Addendum 15 – UN Regulation No. 16

Revision 10 - Amendment 4

Supplement 4 to the 08 series of amendments – Date of entry into force: 5 January 2024

Uniform provisions concerning the approval of:

"Figure 9

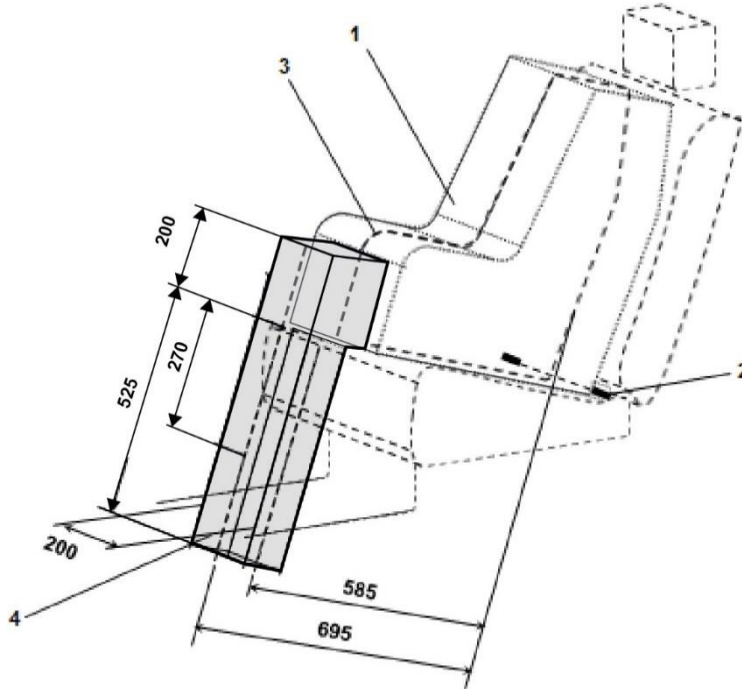
Annex 17, Appendix 2, Figure 9, amend to read:

Side view of the i-Size support leg installation assessment volume for assessing compatibility of the i-Size seating positions with support legs of i-Size child restraint systems

1. Child Restraint Fixture (CRF).
2. ISOFIX low anchorages bar.
3. Plane formed by the bottom surface of the CRF when installed in the designated seating position.
4. Plane passing through the lower anchorage bar and oriented perpendicular to the median longitudinal plane of the CRF and perpendicular to the plane formed by the bottom surface of the CRF when installed in the designated seating position.
5. i-Size support leg installation assessment volume representing the geometrical boundaries for an i-Size ISOFIX child restraint system support leg.
6. Vehicle floor.

"Figure 2

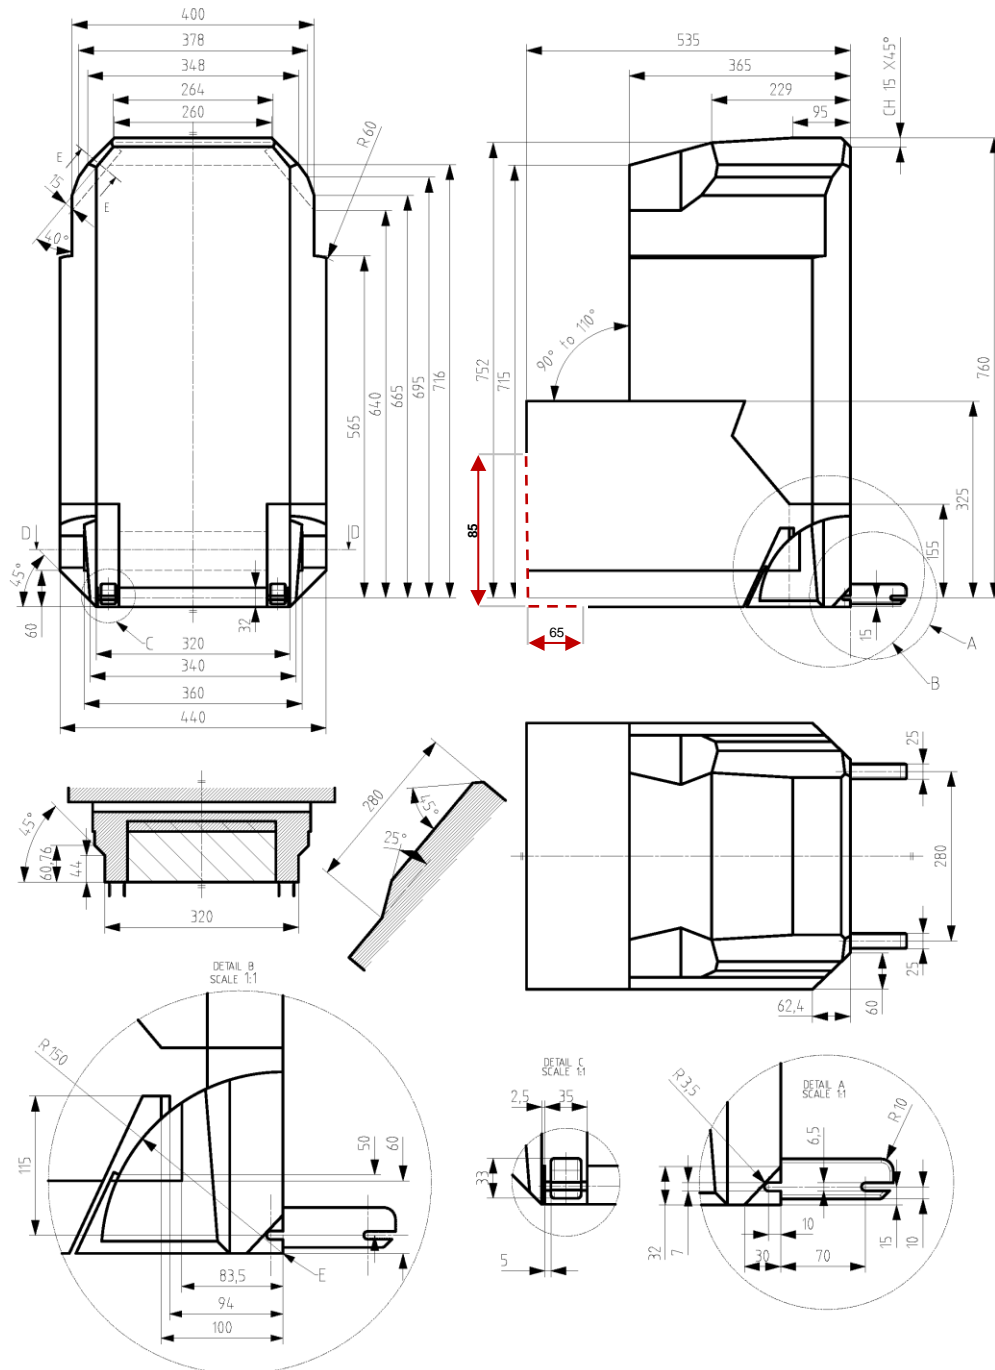
Annex 17 – Appendix 5, Figure 2, amend to read:

ISO/B2: Envelope dimensions for booster seat, reduced width 440 mm - without ISOFIX, or with connectors removed or stowed within the body of the fixture (behind line E, as defined by detail B)

1. E is the Reference axle of rotation of the backrest (90° to 110°) and reference line for retraction/stowing of ISOFIX
2. Dashed lines mark the area where an anti-rotation device, or similar is allowed to protrude"

"Figure 3
**ISO/B3 - Envelope dimensions for booster seat, full width 520 mm - without ISOFIX,
 or with connectors removed or stowed within the body of the fixture (behind line E, as
 defined by detail B)**

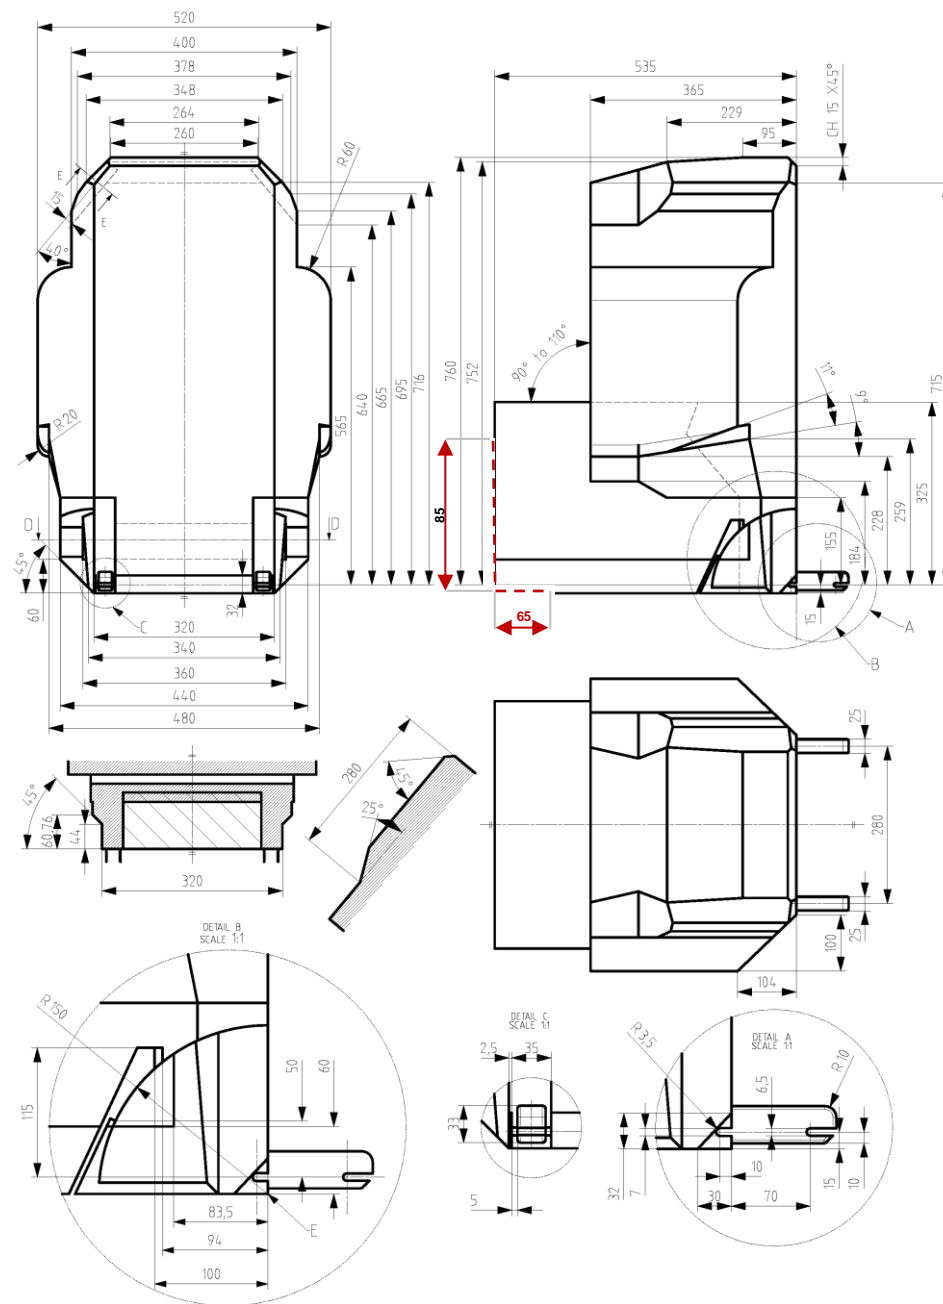
Annex 17 – Appendix 5, Figure 3, amend to read:

1. E is the reference axle of rotation of the backrest (90° to 110°) and reference line for retraction/stowing of ISOFIX
2. Dashed lines mark the area where an anti-rotation device, or similar is allowed to protrude"
